# TOWNSHIP OF WELLINGTON NORTH FERGUS STREET RECONSTRUCTION PROJECT NO. 21340,1; CONTRACT NO. RFT-2024-005

# **ADDENDUM NO. 2**

#### **ENBRIDGE RESTORATION – LOCATIONS 2-3**

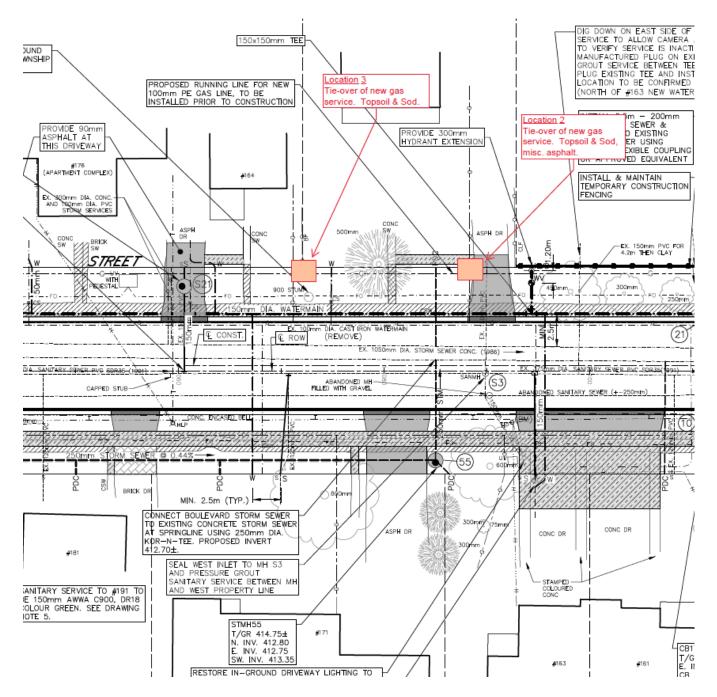
- b) Upon completion of the relocation work, Enbridge's contractor will complete temporary restoration of applicable disturbed areas. Complete restoration shall be performed by the Township's Contractor under this Contract. Details of the required restoration are provided below, and restoration locations are outlined in an attachment to this Addendum. The Contractor shall make note of the revision to the Schedule of Items and Prices contained in the attached page T-11 (Revised), which modifies Item No. 54 to provide a place for the Contractor to include costs for the additional restoration work outlined in this Addendum. The revised page shall be used in the tender submission.

- v. Costs for the restoration of Locations 2, 3, 6, and 7 shall be covered under the existing applicable tender items (e.g. topsoil, sod, etc.) and shall be paid for based on the applicable restored area determined at the time of construction.

#### **ENBRIDGE RESTORATION – LOCATIONS 4-7**

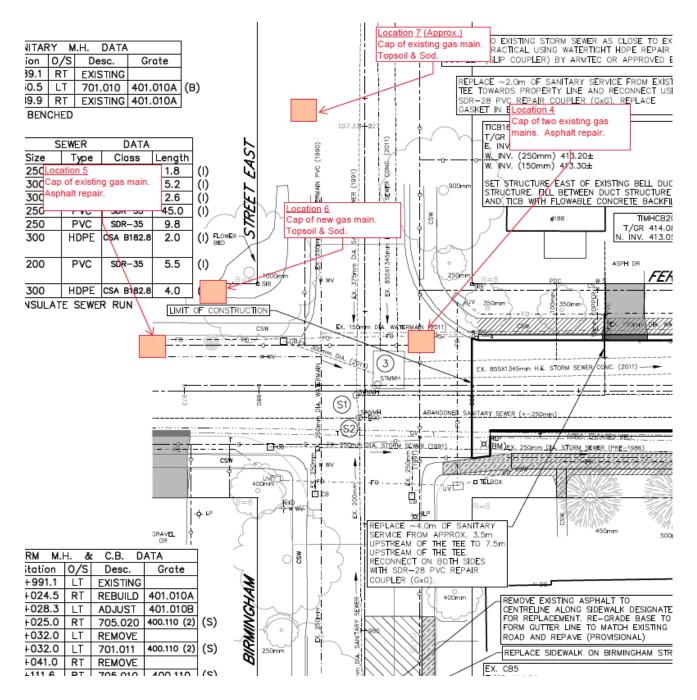
- iii. For restoration at Locations 4 & 5, the Contractor shall assume the following approximate quantities: 2.0x2.0m asphalt patch (2 lifts).
  - iv. The Contractor shall include all costs for restoration required at Locations 1, 4 and 5 in Item #54 a) on page T-11 (Revised).
